**HILLSBURGH HEIGHTS INC.
 PROPOSED RESIDENTIAL SUBDIVISION
 5916 TRAFALGAR ROAD
 TOWN OF ERIN
 FILE NOS. 233T-21002, OP21-01, Z21-09**

**APPENDIX II
 RESPONSE TO SECOND SUBMISSION COMMENTS**

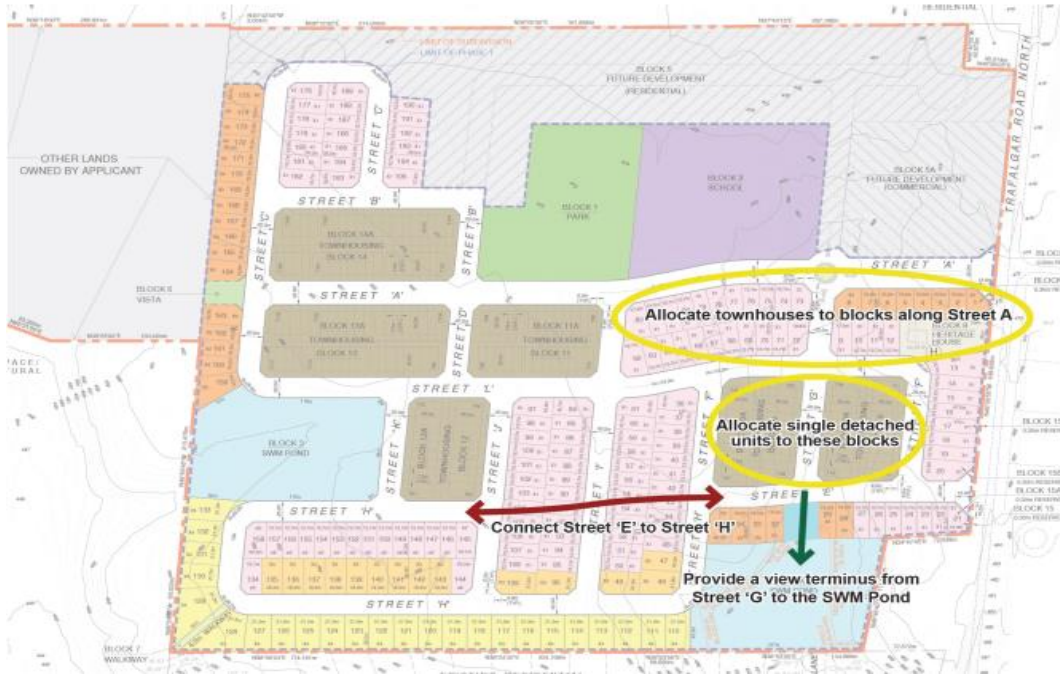
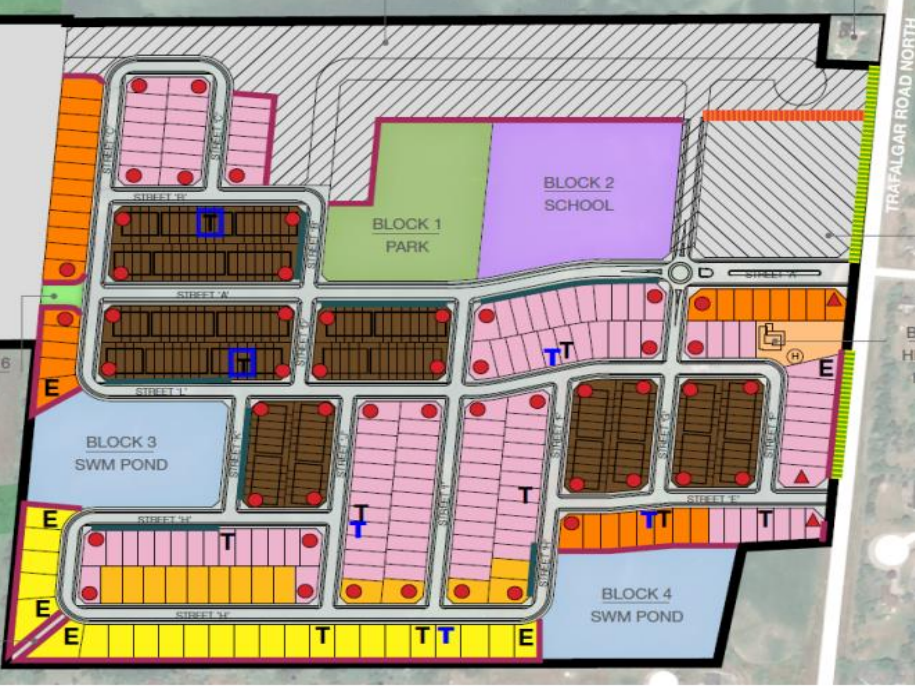
Item	Comments	Response	
	<p>As part of this second review, we have added our comments to the applicant's response matrix, and prepared two annotated plans to support them</p>	<p>NAK/ Candevcon</p>	<p>We do not support the changes to the Draft Plan as suggested. Locating the Townhouse Blocks along Street "A" is not desirable in consideration of additional driveways on Street "A" as well as the design objective of "integrating" the townhouses with single detached rather than a linear concentration. The provision of a view terminus from Street "G" to the SWM pond has been addressed due to the increase in the size of the SWM pond. Connecting Street "E" to Street "H" is not desirable as it would result in Blocks that are too small and would add an additional 150m of road for no perceptible benefit.</p> <p>Diagrams updated to reflect revised draft plan.</p>
